Re: Cover Letter for the Supplemental Information  
60, 67-75, 70-80 Kilmarnock Street and 59-75 Queensberry Street, Fenway

## Response to Comments

**cbt** Figure 5.1g  
Shadow Study  
Summer Solstice - 6pm  
**60 Kilmarnock**  
**Boston, Massachusetts**

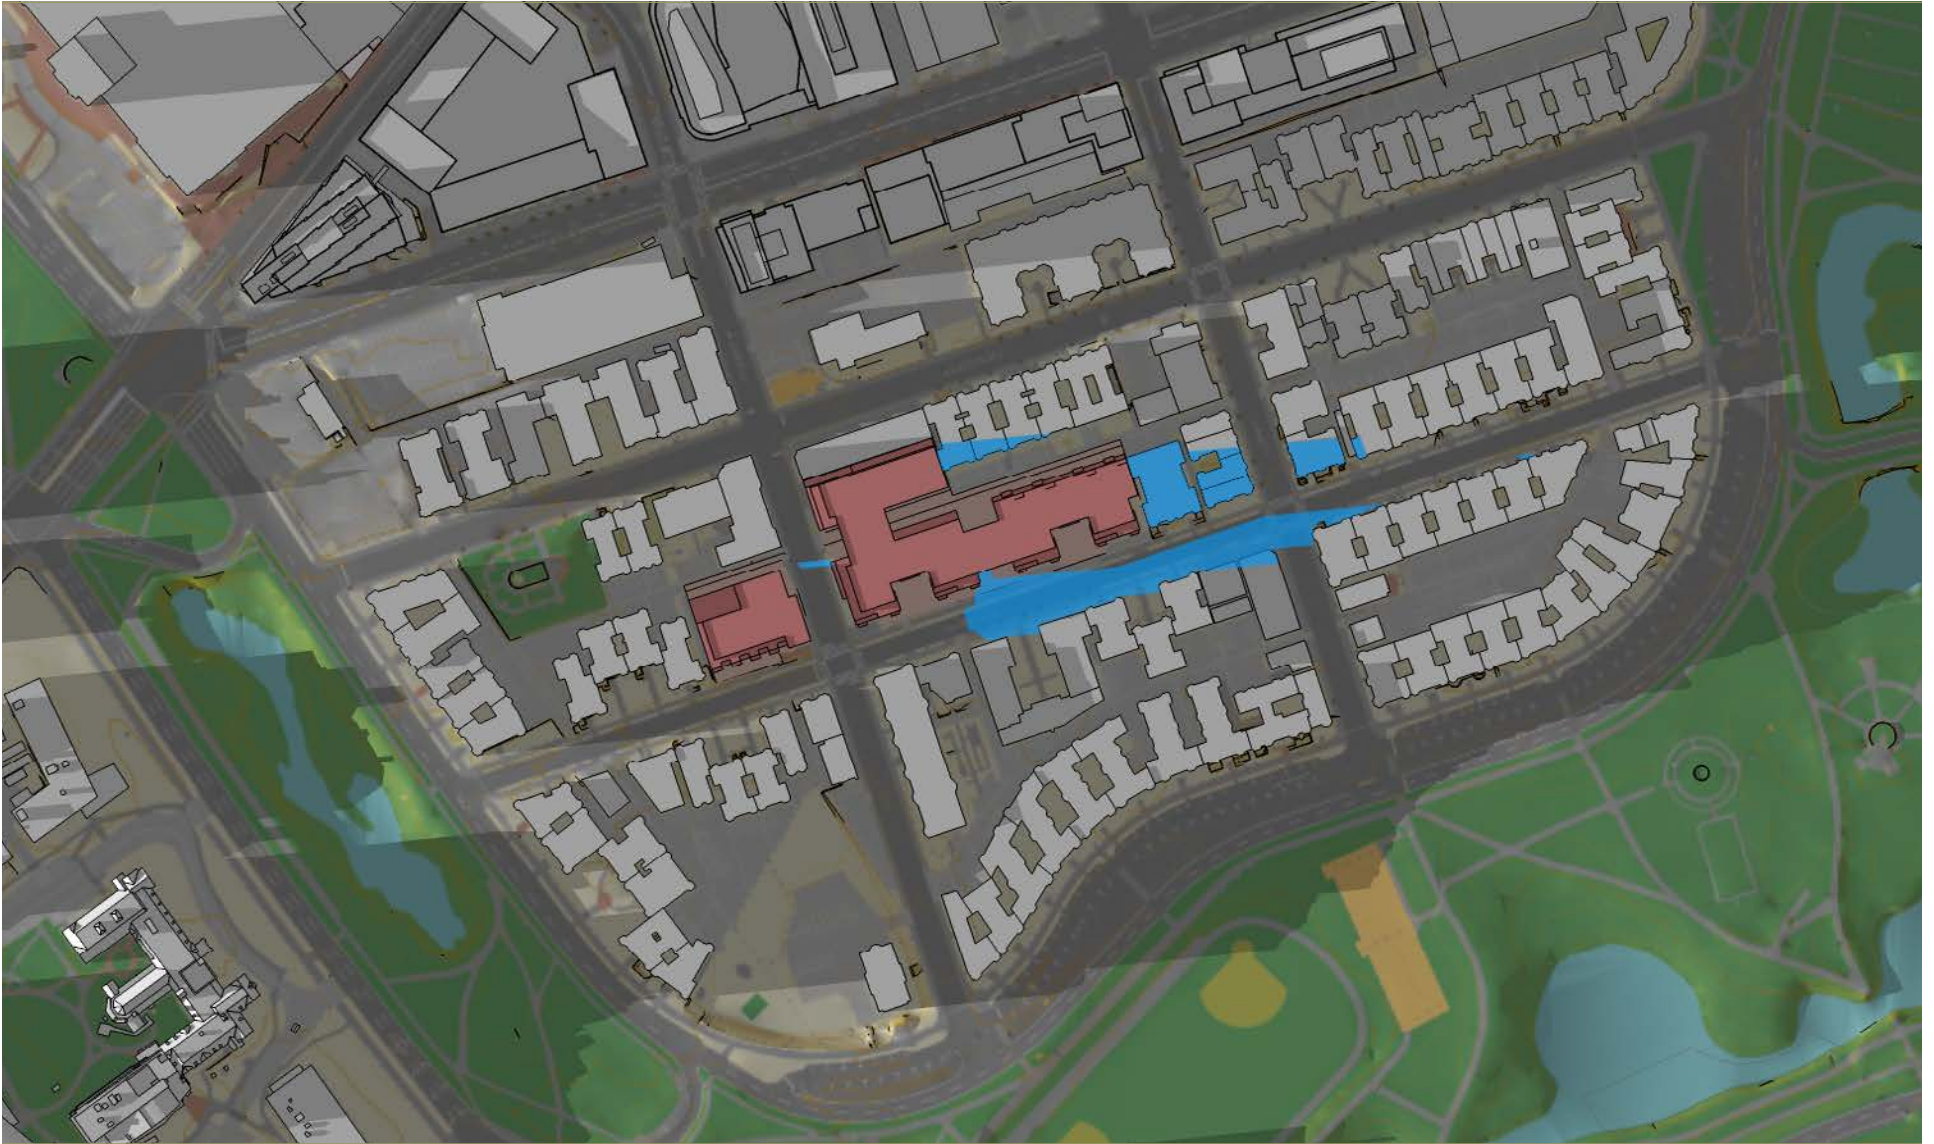
*The shadow analysis illustrations are difficult to evaluate, as the Expanded Project Notification Form (EPNF) contains three illustrations per page, thus the Proponent shall be required to provide one 8 ½ x 11 illustration, per page, for each of the following date and time detailed below:*

*Existing (no-build) and build conditions for the hours of 9:00 a.m., 12:00 noon, and 3:00 p.m. for the vernal equinox, summer solstice, autumnal equinox and winter solstice and for 6:00 p.m. during the summer and fall.*

Please refer to the revised exhibits in Appendix A.

Image 1: PV Layout

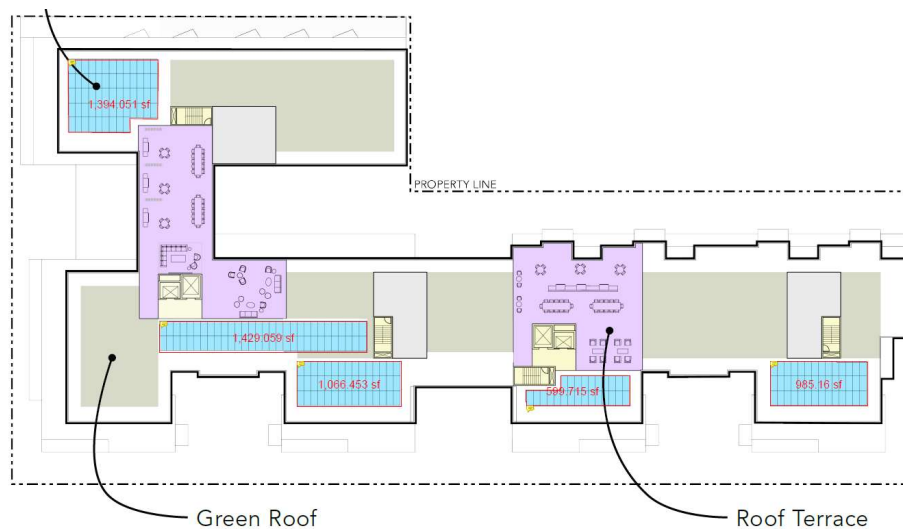
- › *Improving the building envelope design to exceed ASHRAE 90.1-2013 baseline conditions for the corresponding building envelope components.*
- › *Contact utility and state DOE and CEC representatives as soon as possible and identify potential utility and state-funding for energy efficiency and clean/renewable energy support for the project. Provide specific information on all utility and state energy efficiency and renewable / clean energy assistance including energy modeling that will be afforded to the project.*
- › *Include Solar PV on the building. Proponent or third-party ownership is acceptable. Please provide system(s) location, size, and output information.*

The Kilmarnock development is considering rooftop photovoltaic (PV) arrays. These are unshaded and provide unobstructed solar access (*Image 1*). Two scenarios were analyzed, flat PV arrays and a 40-degree configuration.

If PV panels were to be installed at 40-degrees on the available portions of the roofs, a total of 52 kW of panels generating 69,373 kWh per year, the value of the electricity generated would be approximately \$9,712 and the installation cost is approximately \$100,500 yielding a simple payback of 10.34-years (Table 2).
